Paycor Stadium Southeast & Southwest VT Escalator Towers
Bid Package 3: Architectural & MEP
ITB#037-26
Addendum 2

May 12, 2026

ELECTRICAL PARTIAL PLANS LEVEL 400 NEW WORK POWER

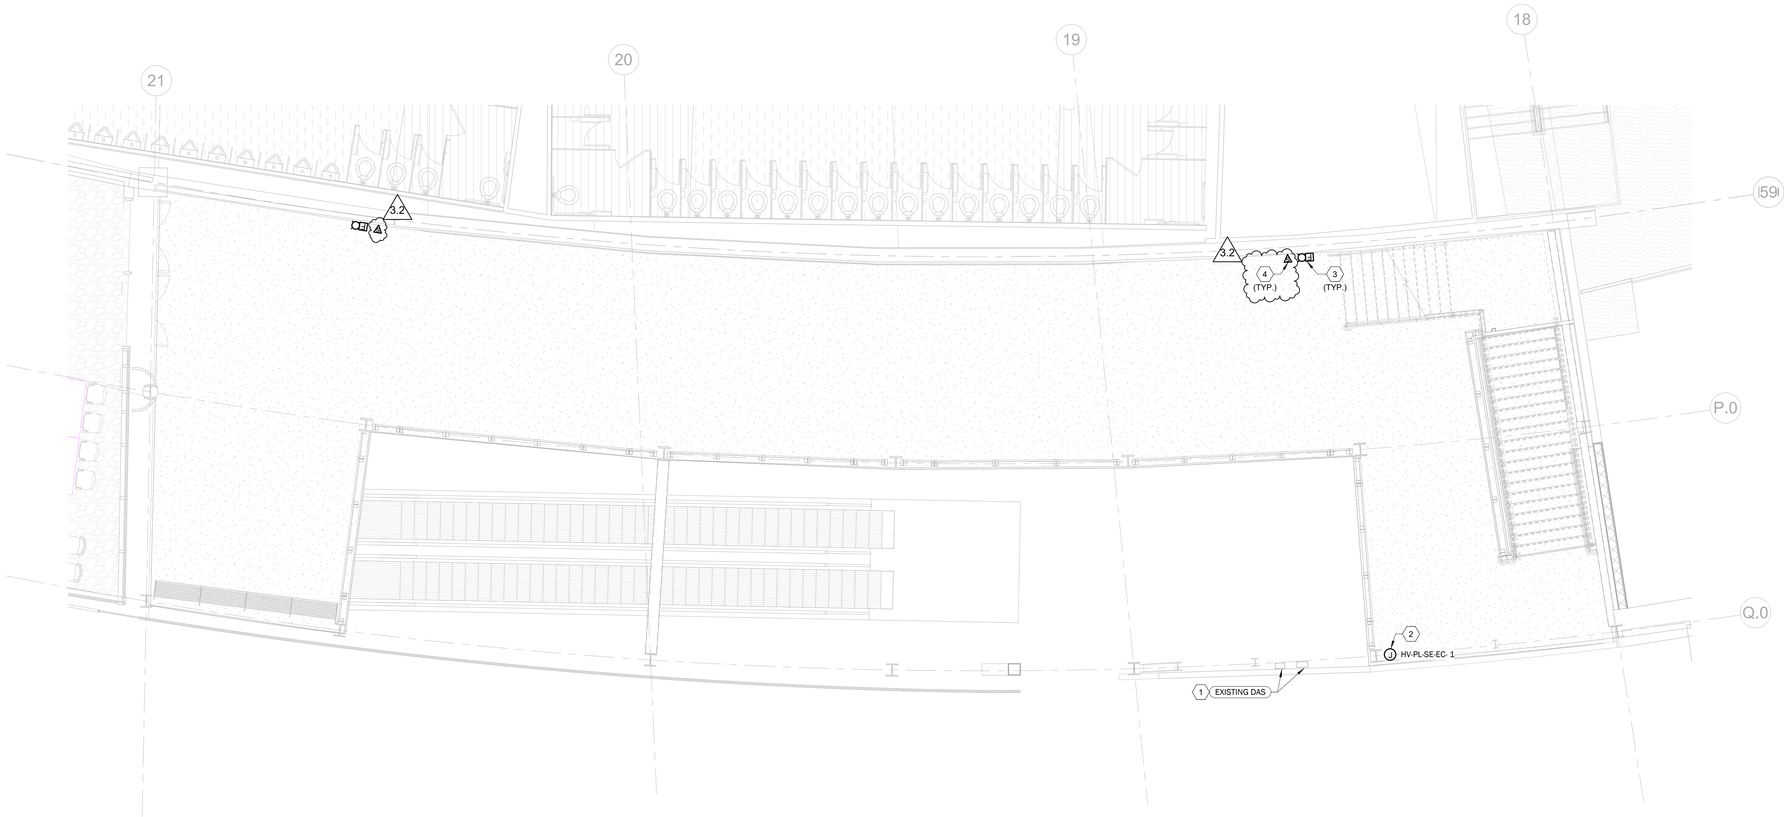
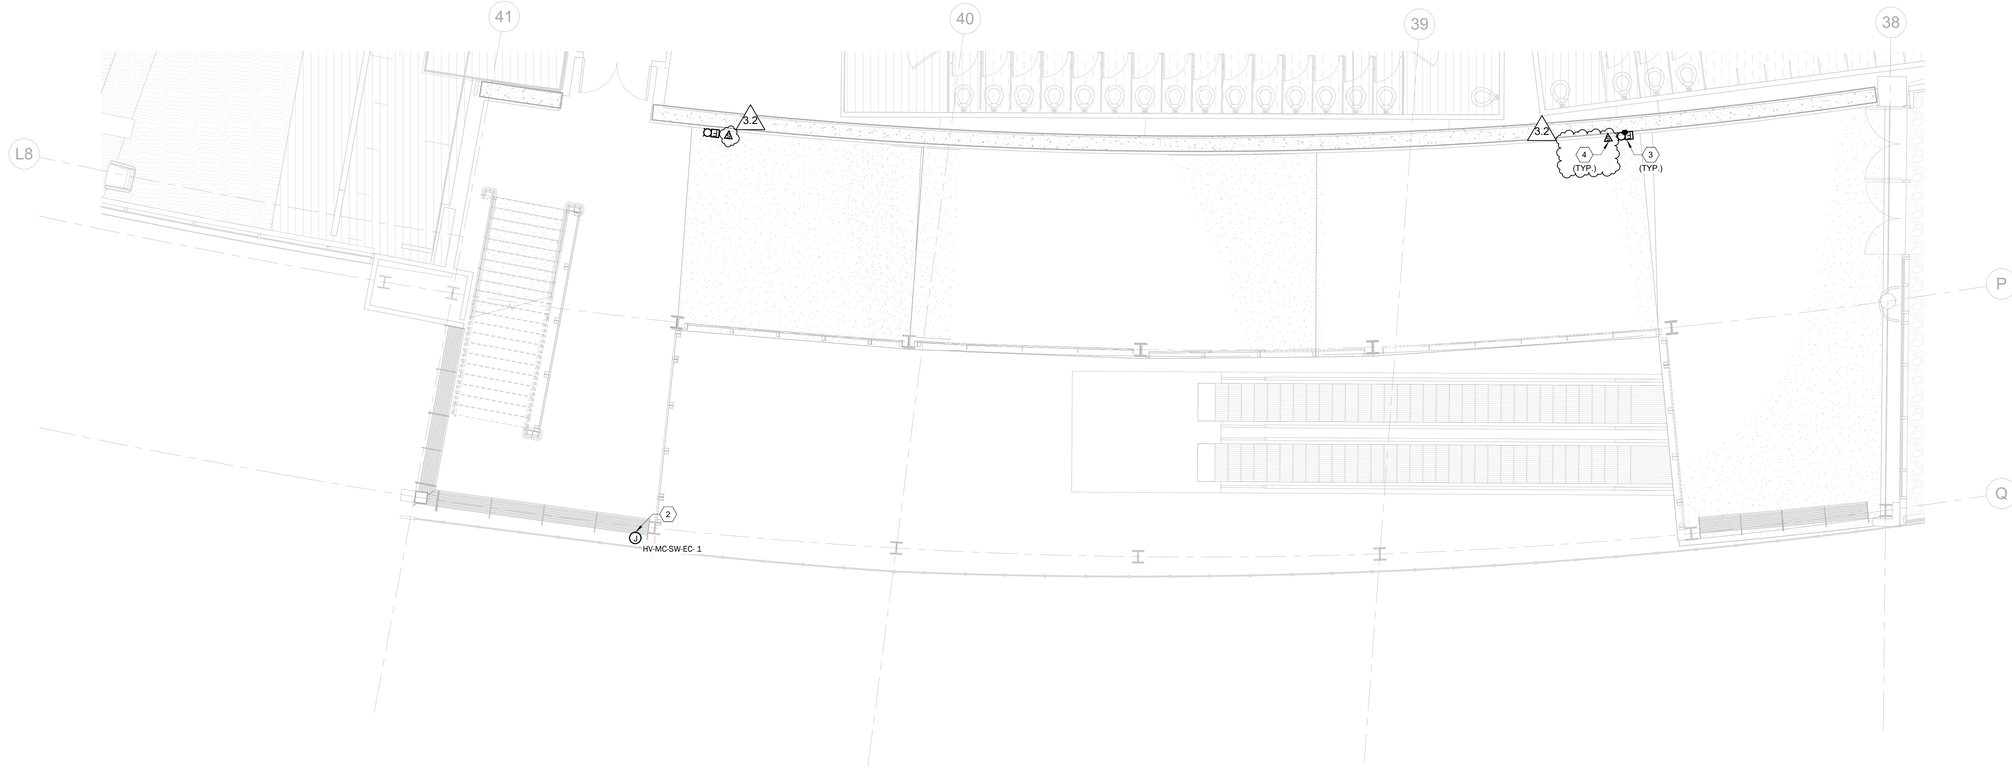
2.22 E202: ELECTRICAL PARTIAL PLANS LEVEL 400 NEW WORK POWER
- 2.22.1 Edited Drawing Note 2.
- 2.22.2 Added speakers.
- 2.22.3 Deleted General Note.

ELECTRICAL PARTIAL PLANS LEVEL 500 NEW WORK POWER

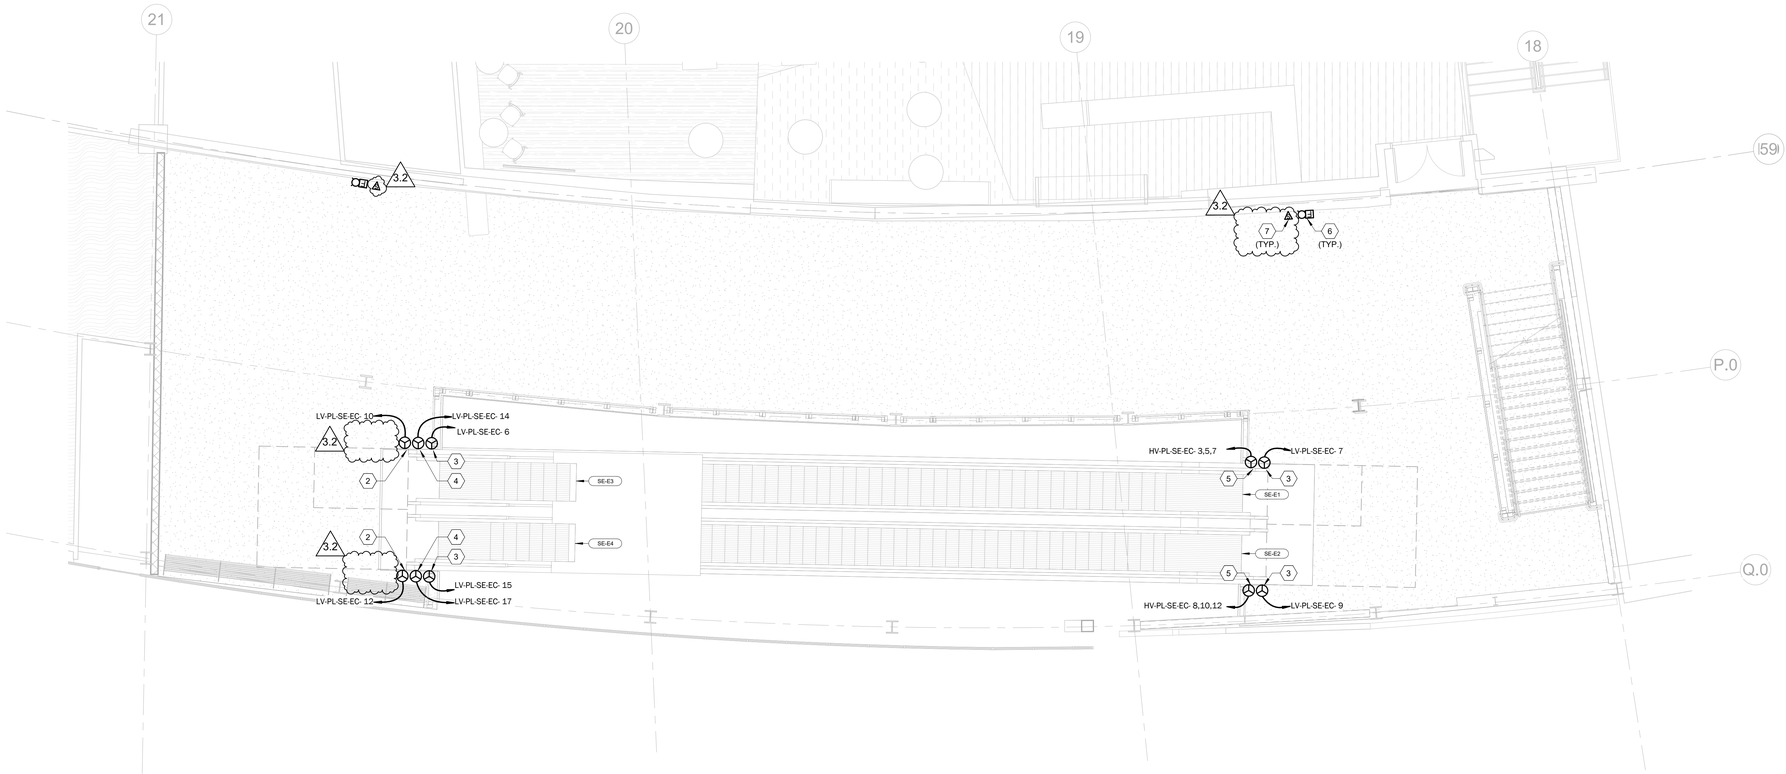
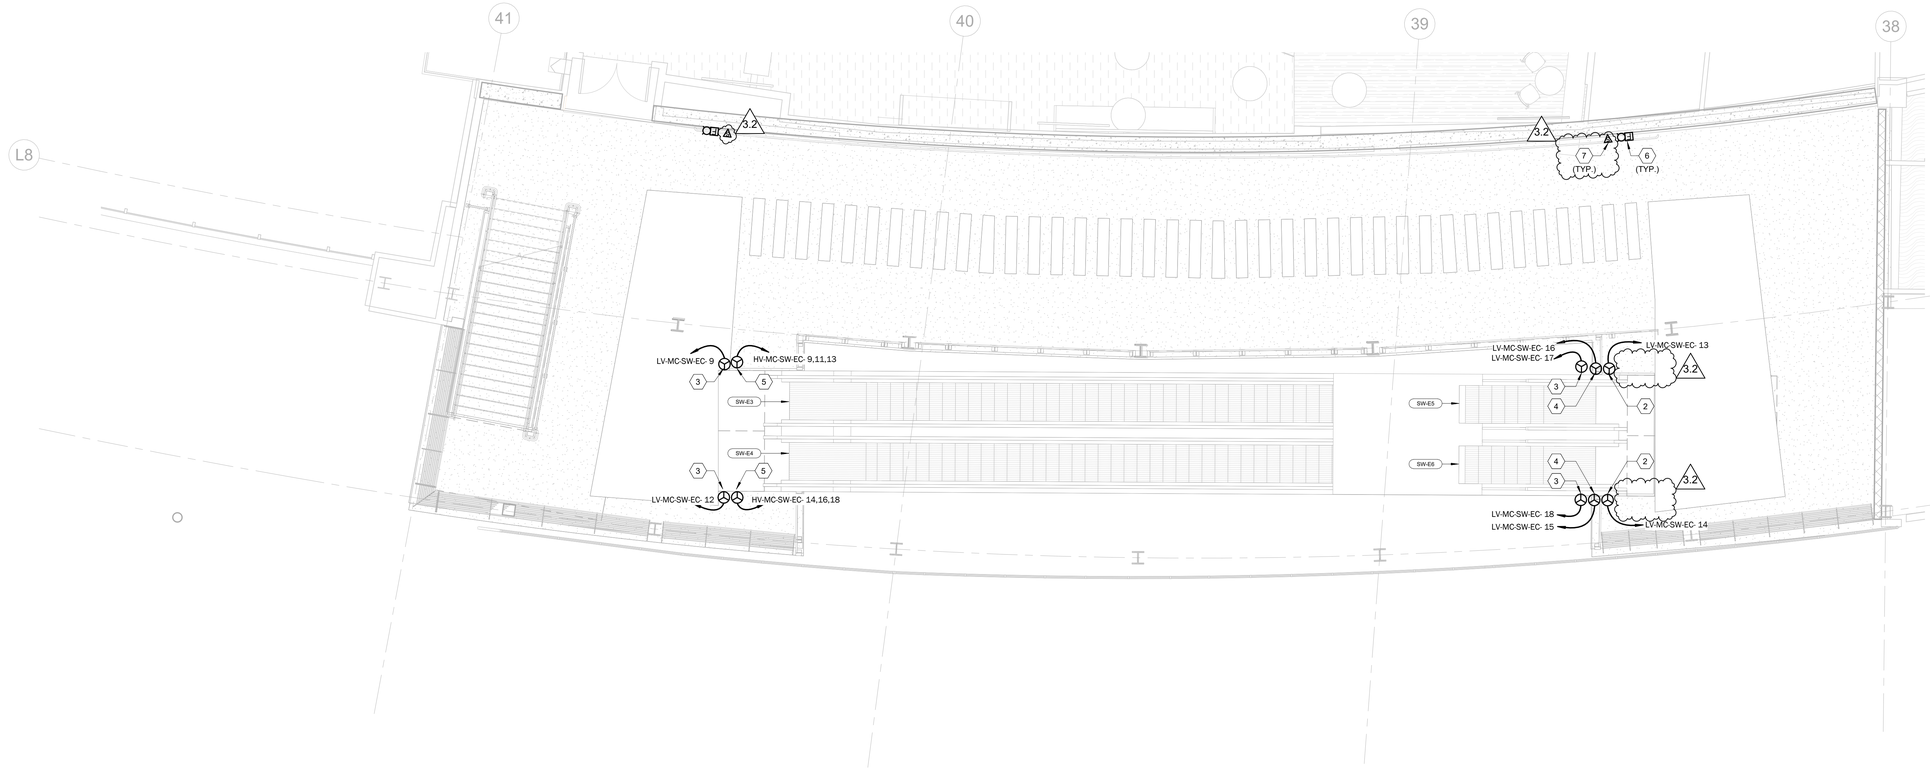
2.23 E203: ELECTRICAL PARTIAL PLANS LEVEL 500 NEW WORK POWER
- 2.23.1 Added speakers.
- 2.23.2 Removed truss heaters.
- 2.23.3 Deleted General Note.

ELECTRICAL PARTIAL PLANS LEVEL 600 NEW WORK POWER

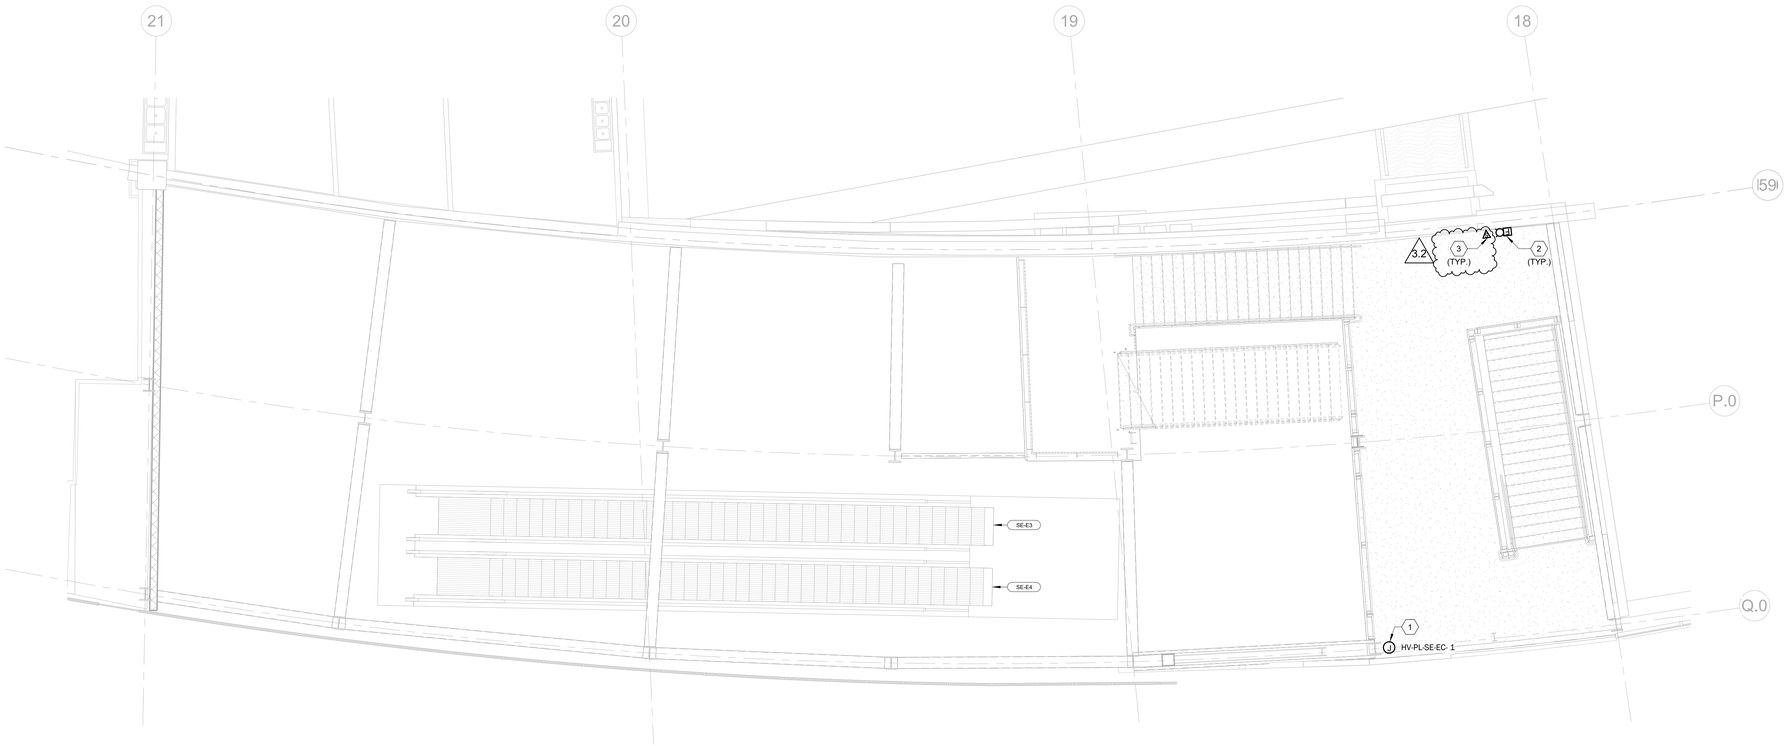
2.24 E204: ELECTRICAL PARTIAL PLANS LEVEL 600 NEW WORK POWER
- 2.24.1 Edited Drawing Note 1.
- 2.24.2 Added speakers.
- 2.24.3 Deleted General Note.

ELECTRICAL PARTIAL PLANS LEVEL 200 NEW WORK LIGHTING

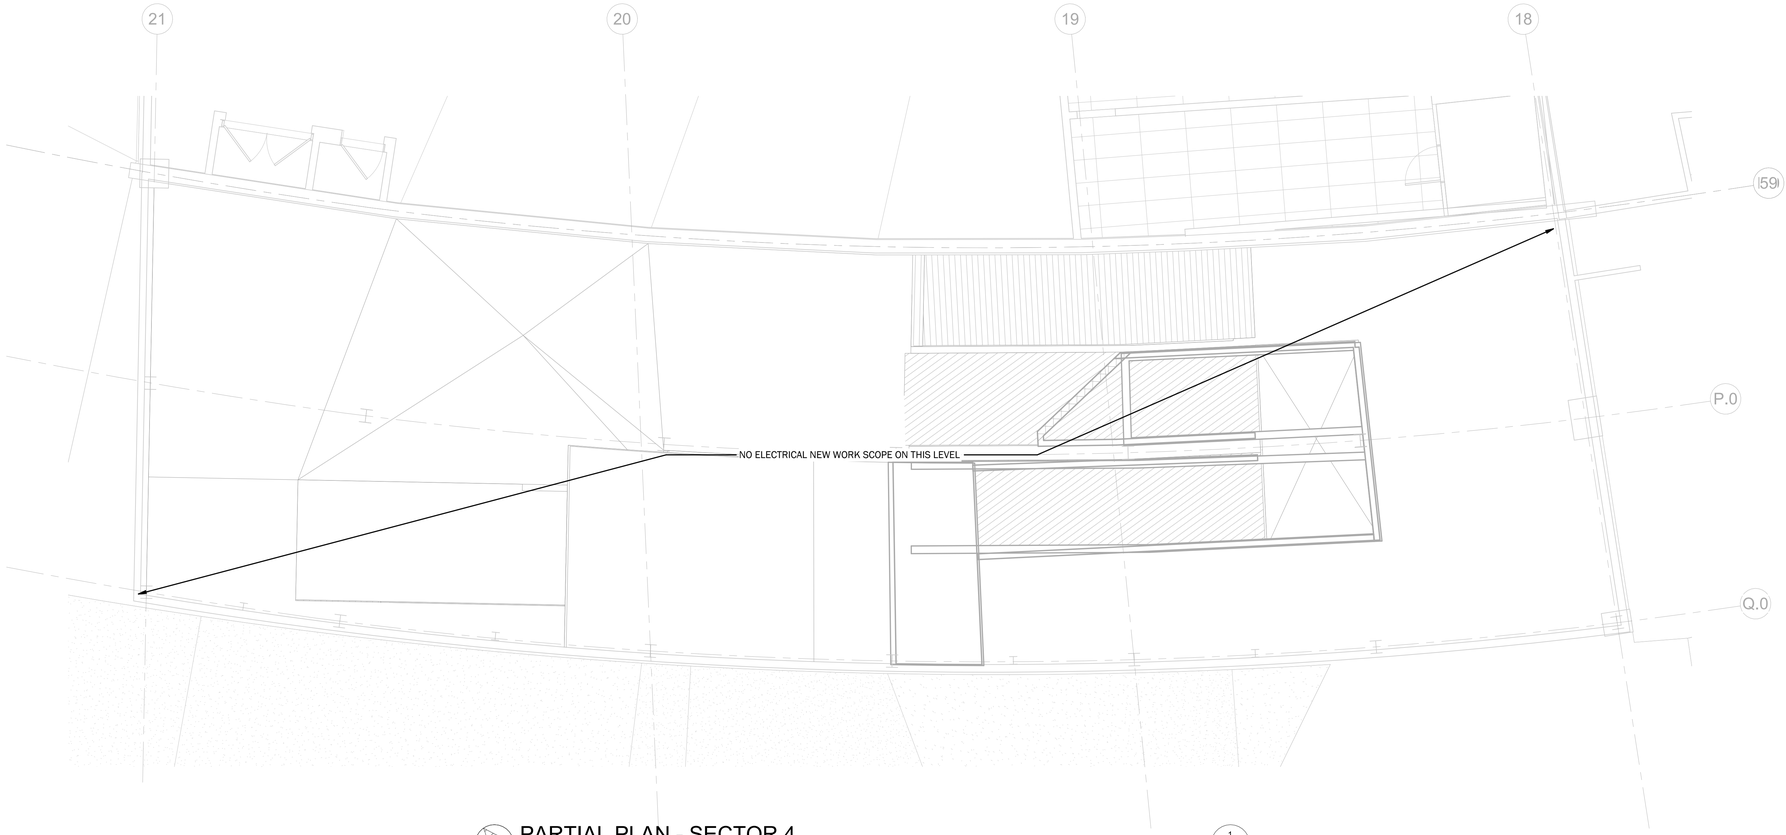
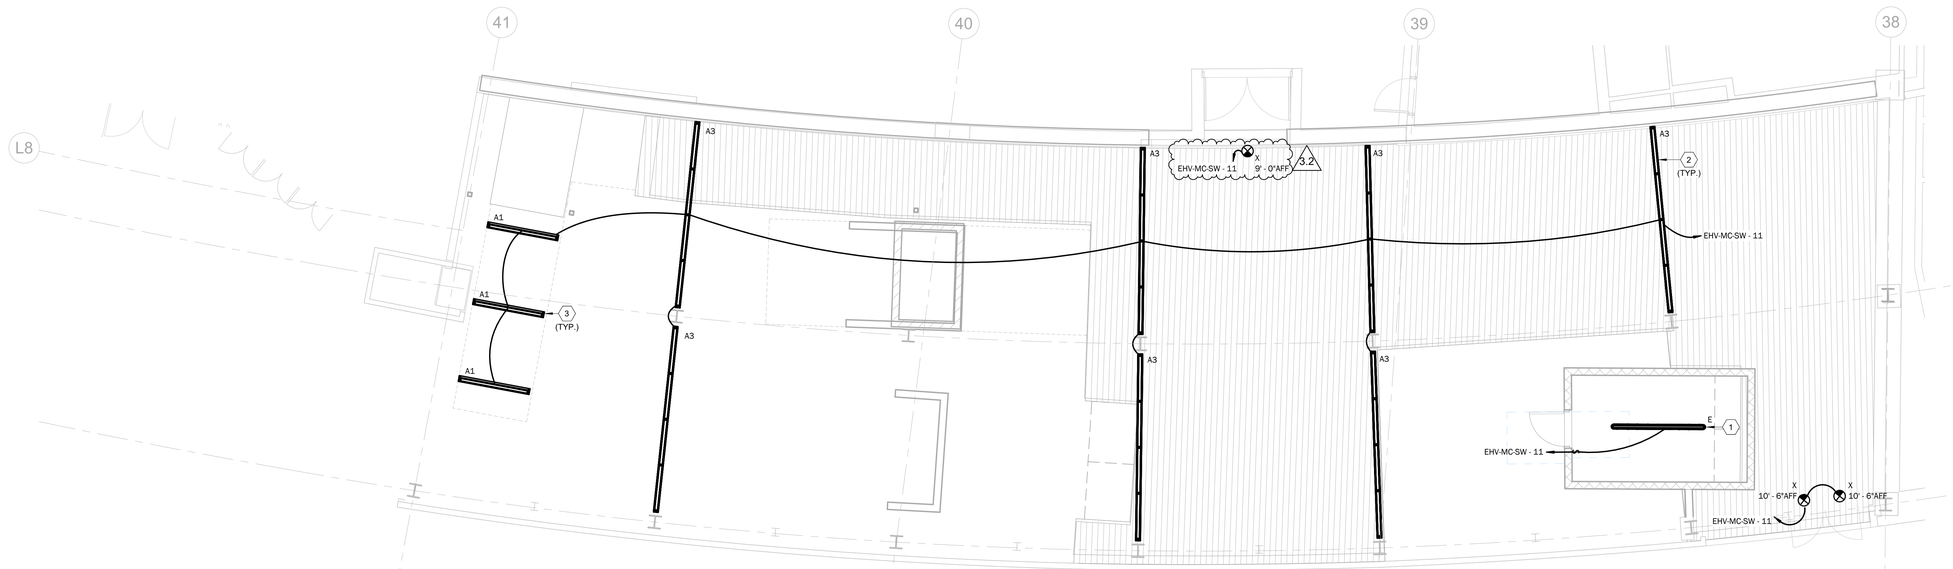
2.26 E206: ELECTRICAL PARTIAL PLANS LEVEL 200 NEW WORK LIGHTING
- 2.26.1 Added exit sign.
- 2.26.2 Deleted General Note.
